Project Name: Avalon (White Lake Hill, LLC)  
 Description: Preliminary site plan approval  
 Date on Agenda this packet pertains to: June 9<sup>th</sup>, 2022

**RE: The Avalon- f.k.a. White Lake Hill- Preliminary Site Plan Review – 4<sup>th</sup> Review**

**RE:** The Avalon  
Rezoning and Preliminary Site Plan – Review #4

**P-2.4**

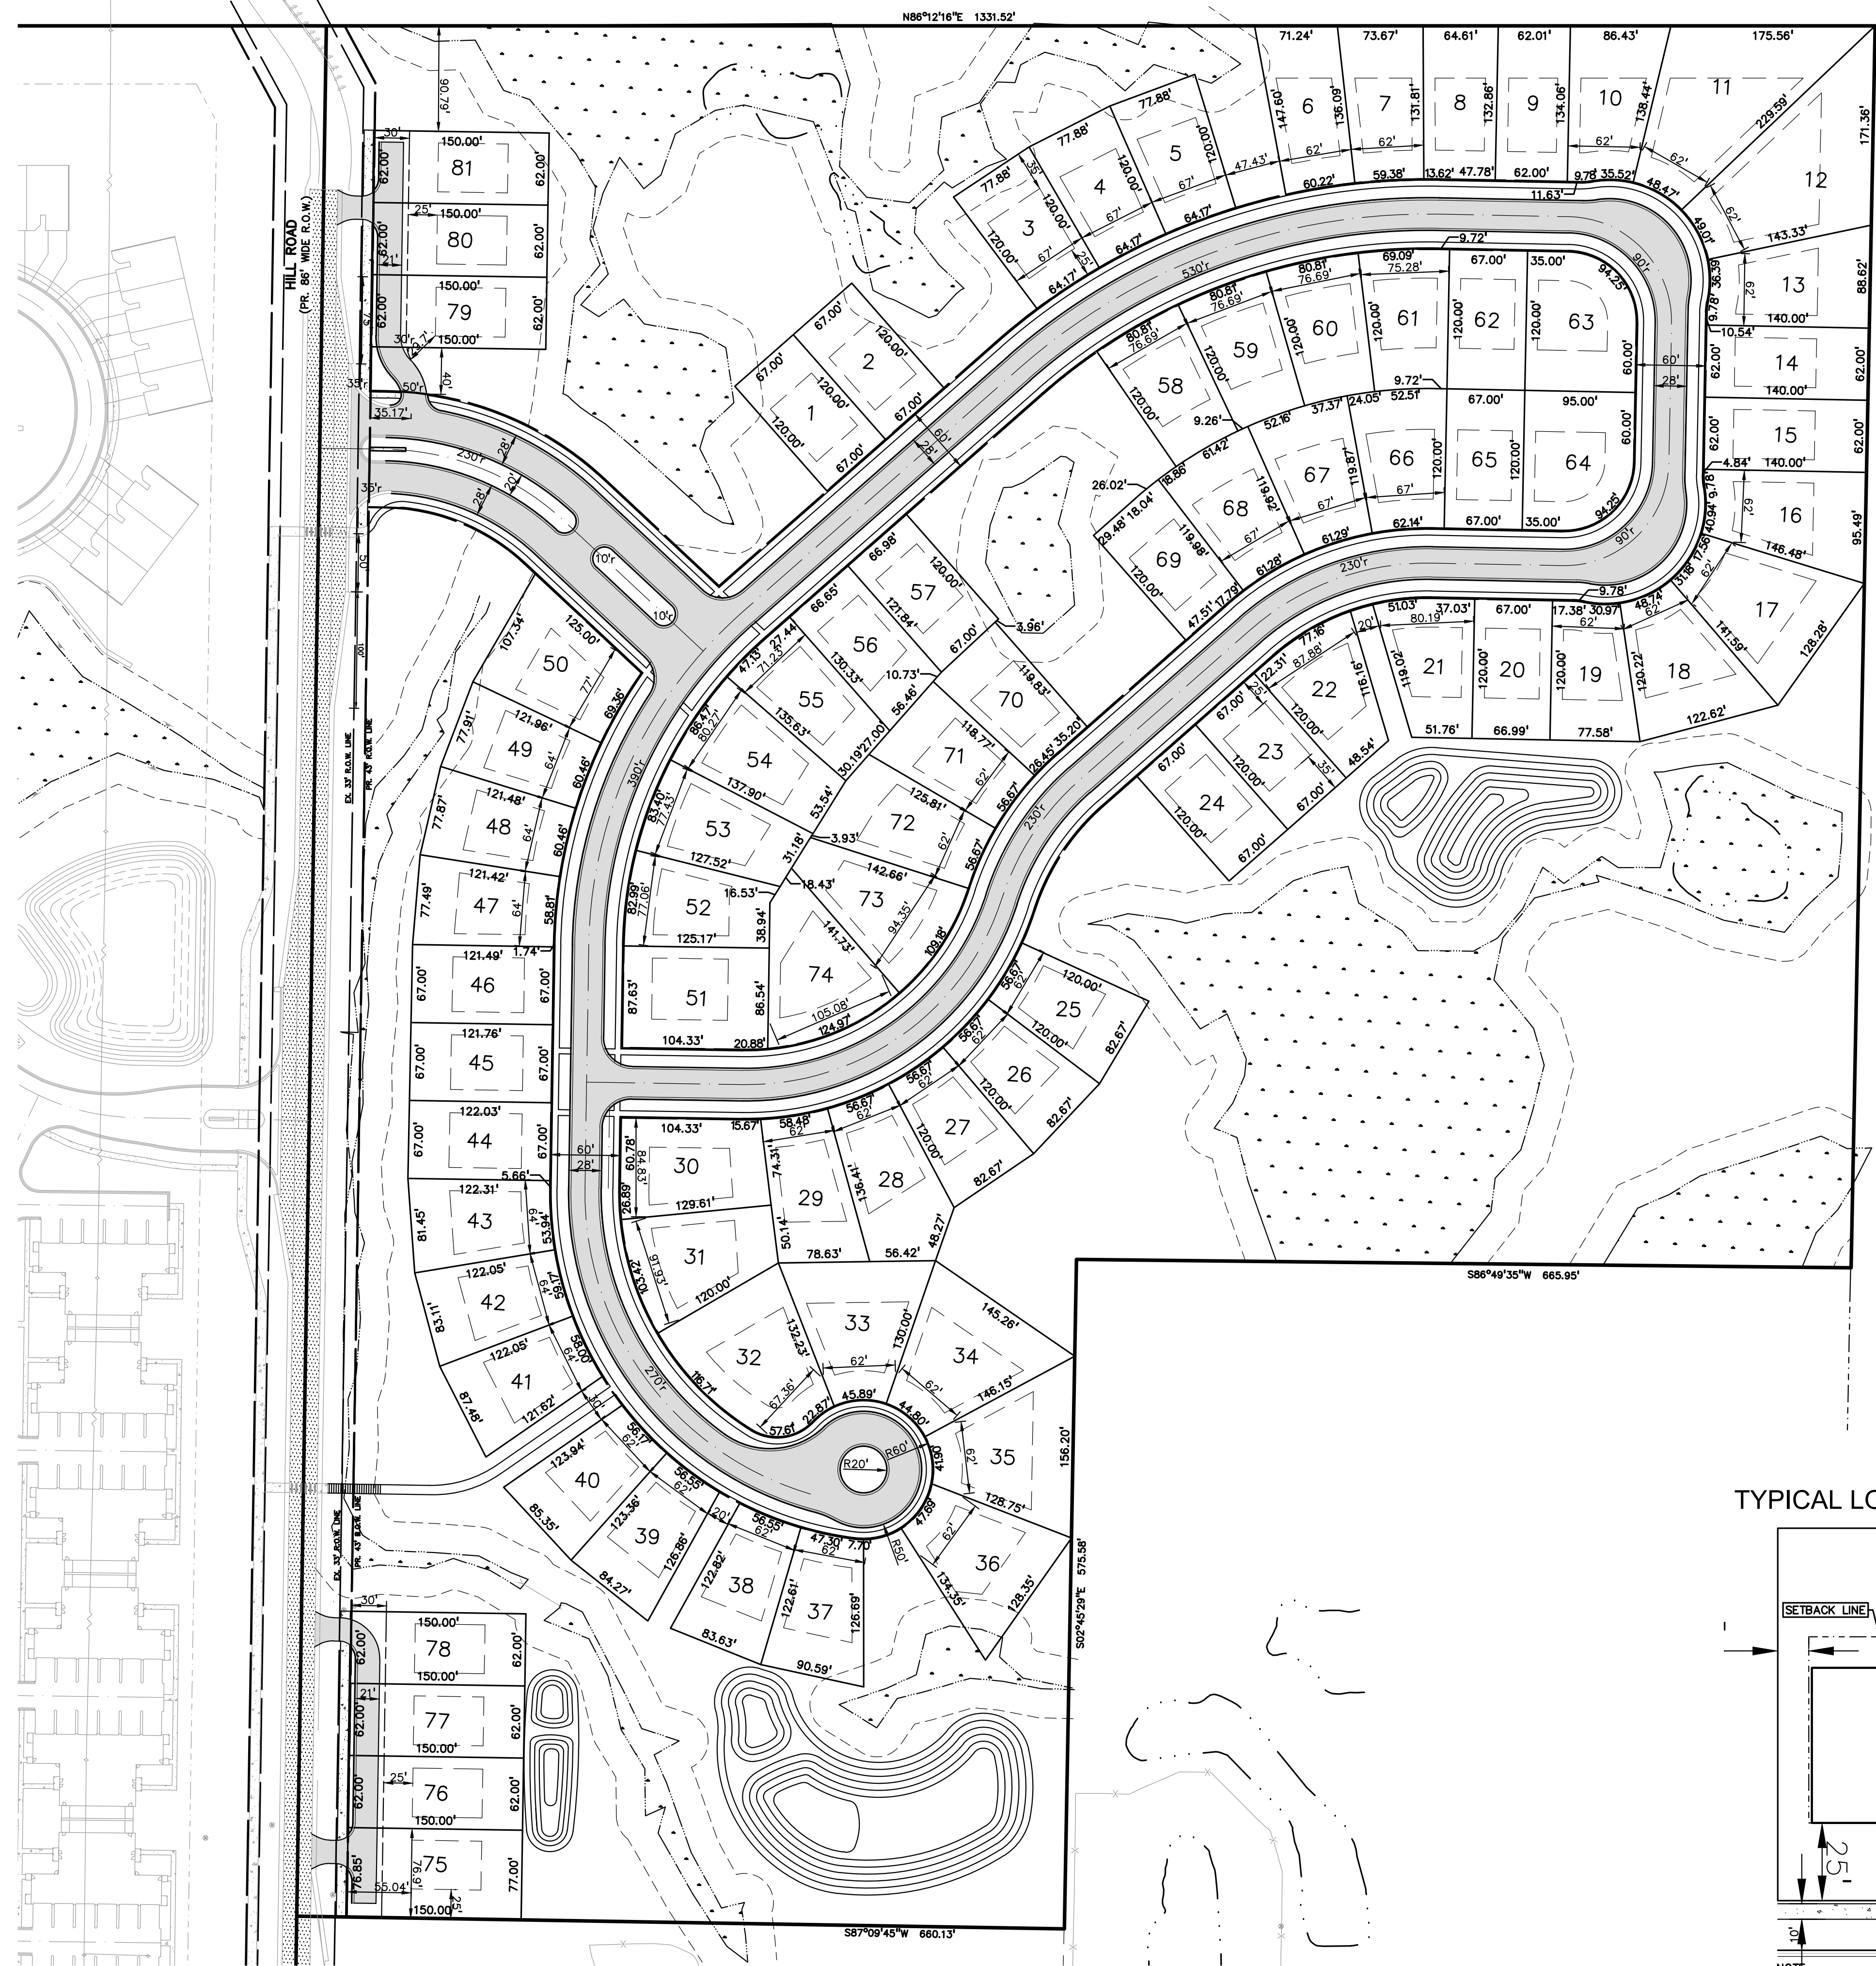
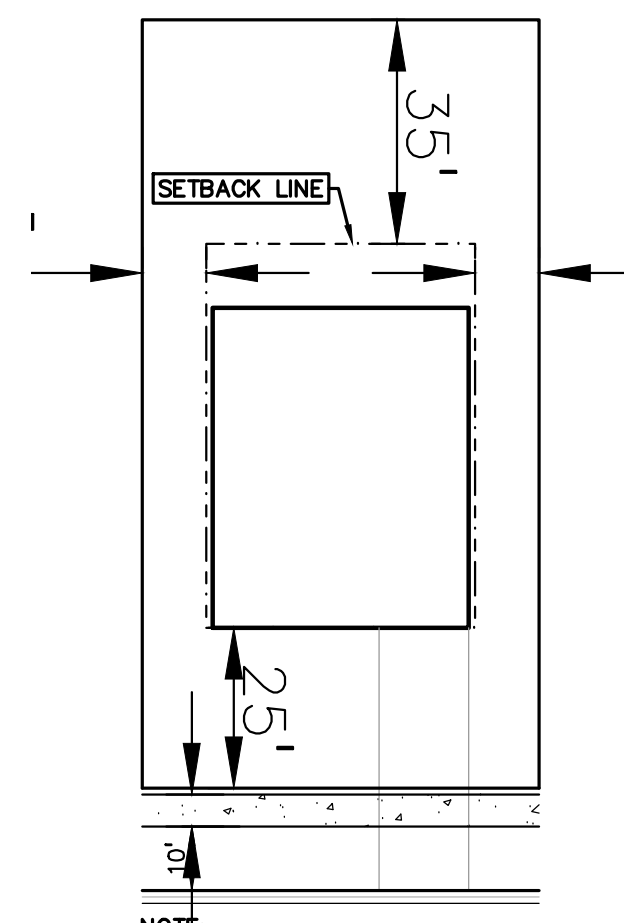
Separate from the waiver request, the note under the typical lot layout on Sheets P-2.3 and P-2.4 of the site plan shall be revised to add the word “within” following the word “encroaching.” Also, the words “wetland buffer” shall be replaced with the words “natural features.” **Comment outstanding.**
